SAFETY RELATED RECALL

Global Recall Action
Number: H468v3

Subject: High Voltage (HV) Battery Busbar Fixings	Publication No.: H468v3
	Model: I-PACE (X590)
	Model Year: 2019 - 2021
	Date of Issue: 29 April 2024

SERVICE INSTRUCTION - H468V3

E357225

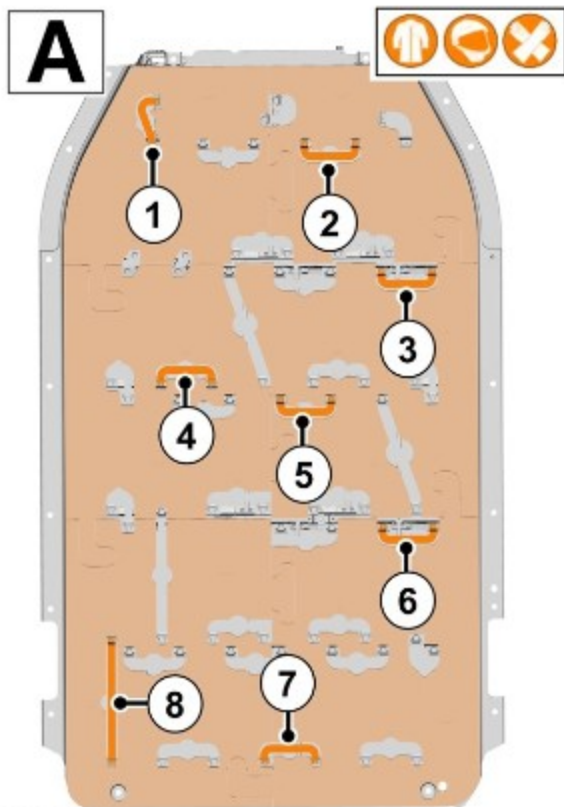
To:	All National Sales Companies (NSCs), importers, retailers and authorized repairers.
For the Attention of:	The approved JLR retailer/authorized repairer.
Important:	NOTE: The information in this campaign is intended for use by professional technicians. If you are not a JLR retailer/authorized repairer, do not assume that a condition described affects a specific vehicle. Contact an authorized JLR retailer/authorized repairer to determine if this campaign applies to a specific vehicle. This bulletin has been amended to update step 11 of the Service Instruction

11. Install pieces 1,2,3,4,5 and 6 of the [HV](#) battery busbar assembly jig JLR-415-081, make sure that the busbar cut outs align with each busbar position.
